Appendix B: Agency and Local Government Coordination

Project: 22-390 PEL

Purpose: Technical Advisory Committee

WYO-22 and WYO-390
Planning and Environmental Linkage Study

What Median Treatment?

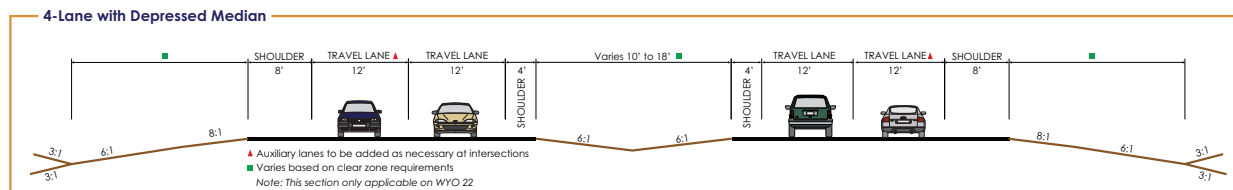
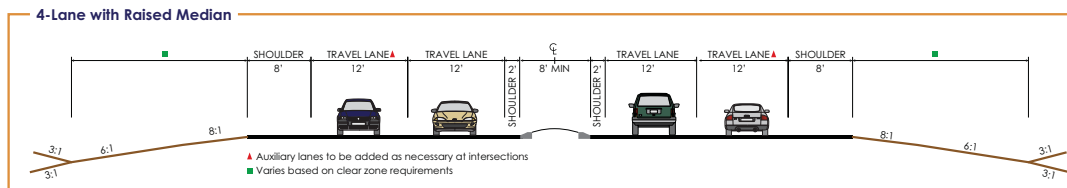
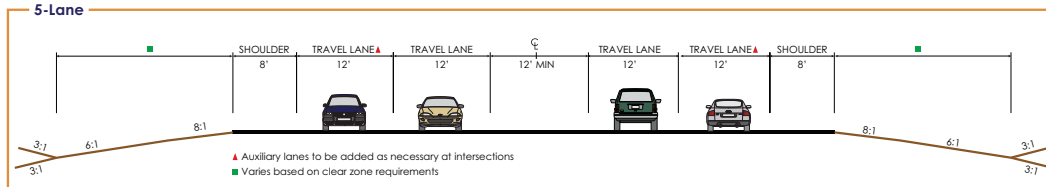
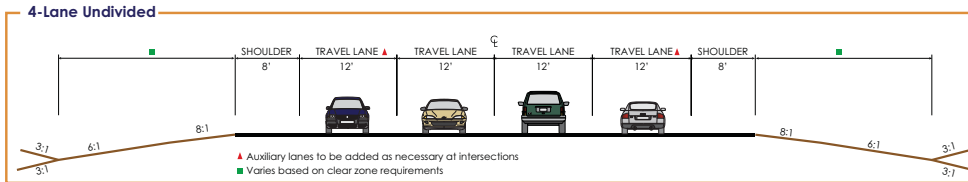
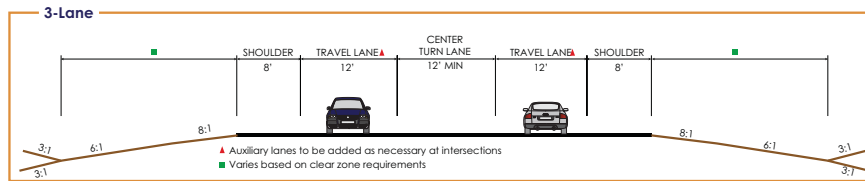
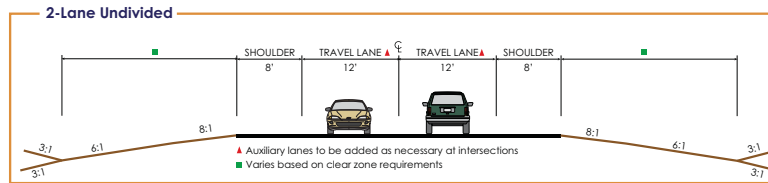
- d. TAC comments on Level 1 screening received by February 1 included:
 - i. Add a queue jump to the intersection layouts - completed
 - ii. The typical cross-sections should state that the lane widths are not final, but to be determined later during evaluation of design options - agreed. A note will be added to the graphic.

Cross-sections are not final; depicted lane widths reflect WYDOT design standards.

WY 22 & WY 390 Intersection

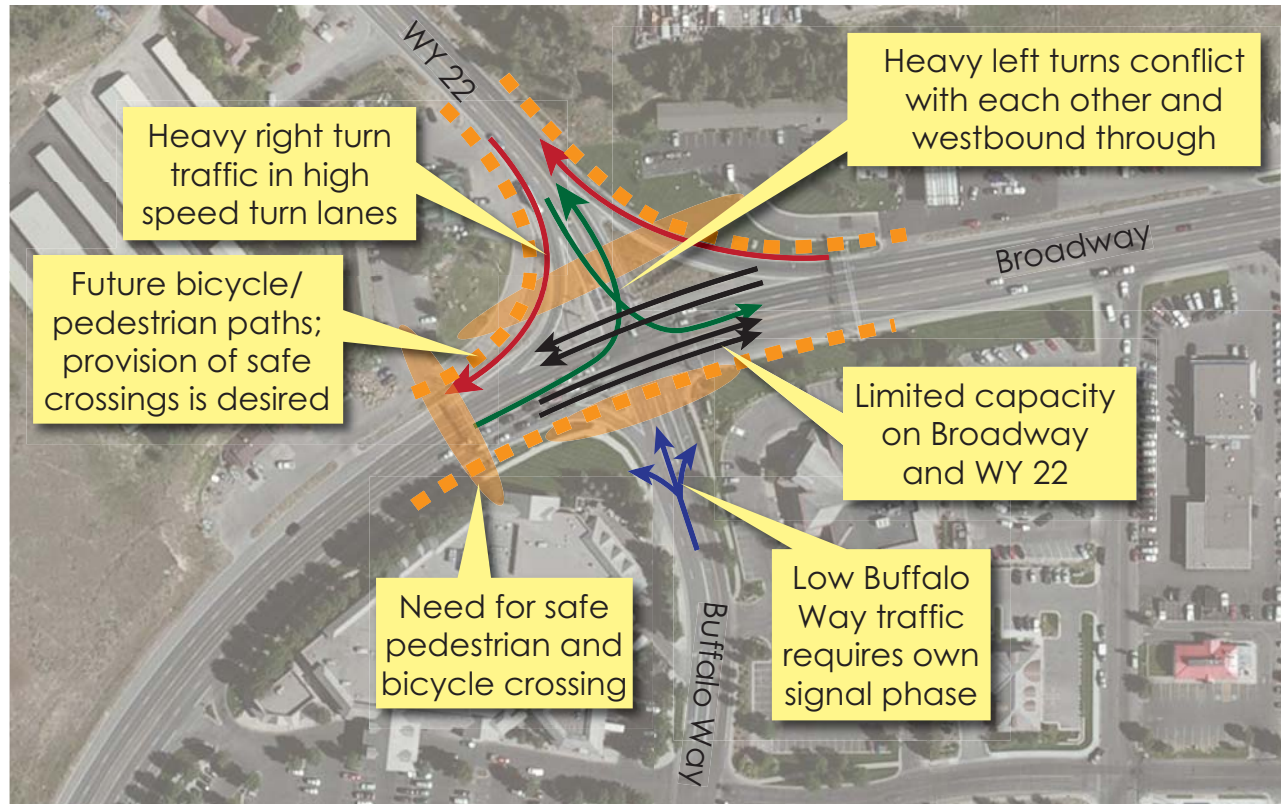
The screening should reflect the transportation goals of the recent Town and County Comprehensive Plan.

Roundabouts should be rated 'medium' for pedestrians and bicyclists, as treatments could be added to facilitate safe pedestrian and bicycle movements.

"Y" Intersection

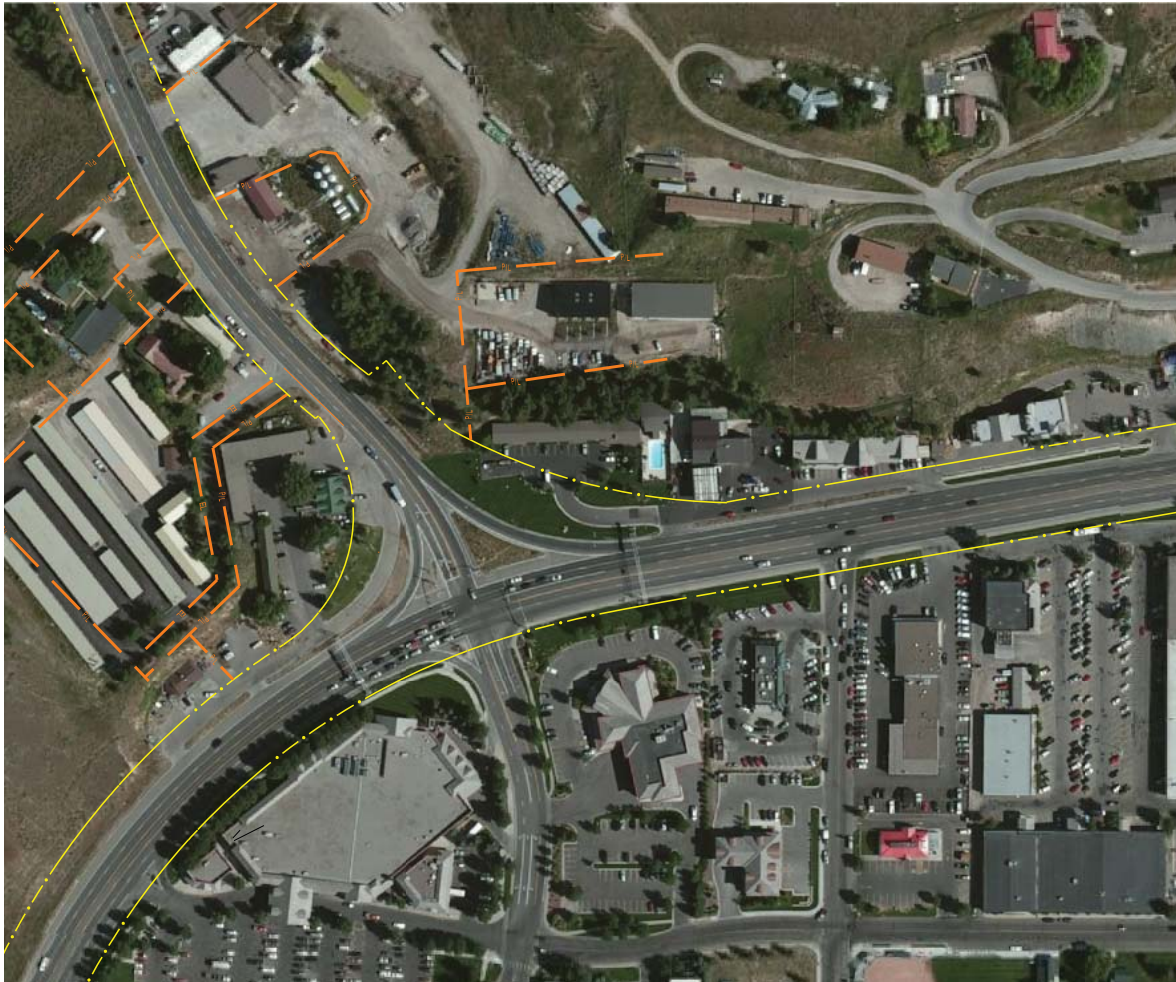
The operations at adjacent intersections need to be thoroughly analyzed.

Closing Buffalo Way is not practical.

Explore more grade-separated options.

Grade separated facilities for pedestrians and bicyclists is desired.
